Sumter City-County Planning Commission

March 23, 2011

PD-04-15 (Rev 4), Hunters Crossing (City)

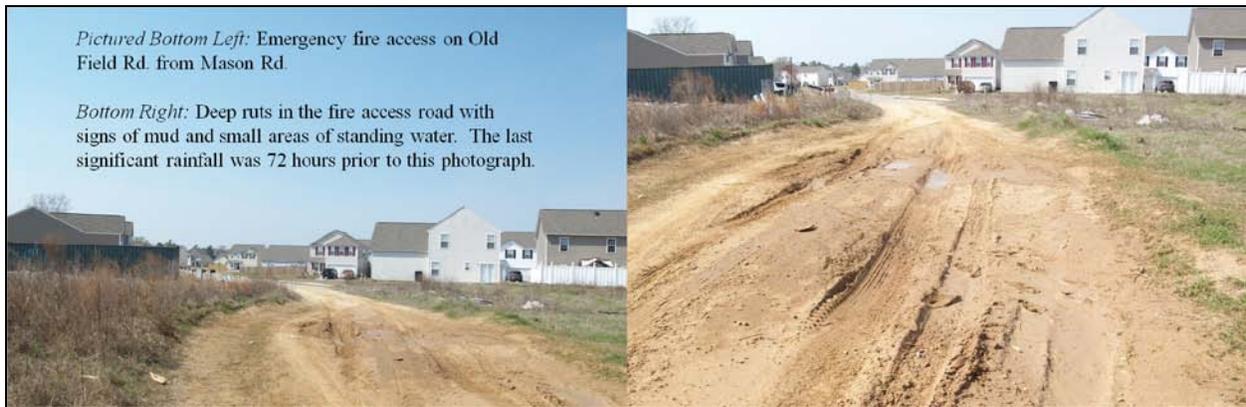
Fire Access – Robbie Rickard, Fire Inspector for the City of

Sumter stated that he has serious concerns about the safety of and ability for a Ladder Truck to access the subdivision from either end of Old Field Rd.

The subdivision currently has 272 approved platted lots with only one paved access from Mason Rd. As shown in the graphic on the previous page, there are two other locations on the property that at some point will become paved roads integrated into the fabric of the subdivision.

Neither of the two unpaved access points meets safety standards for a ladder truck to safely get into the subdivision in an emergency. Both accesses are sand and clay and have not been stabilized through the addition of gravel or other durable surface. As shown in the photographs below, these dirt drives are susceptible to rain and could cause access issues for a fully loaded ladder truck during a storm event.

On a March 1, 2011 meeting with the applicant’s representative, Planning Staff discussed the issue of fire access and overall subdivision access. At that time, Staff requested that the applicant present a timeline for installation of one or both paved access points on Old Field Rd. To date, the applicant has given no indication on the timing for installation of one or both fully paved access points. Due to the existing number of dwellings already constructed within the subdivision, upgrades to fire access should be addressed through the establishment of a finite date for installation of paved roads.

In addition, there are safety concerns related to access in this development. Access issues can only be addressed through the provision of a concrete timeline for implementation of additional paved access points. There has been serious concern expressed about the utility of Old Field Rd. for emergency access due to substandard dirt and clay road beds that are susceptible to washing out and filling with water. 300+ residential lots being accessed by a single point that meets all safety standards puts undue stress on the transportation network and is a formula for disaster should there be a medical or fire emergency when alternate emergency access routes are impassible due to weather conditions.
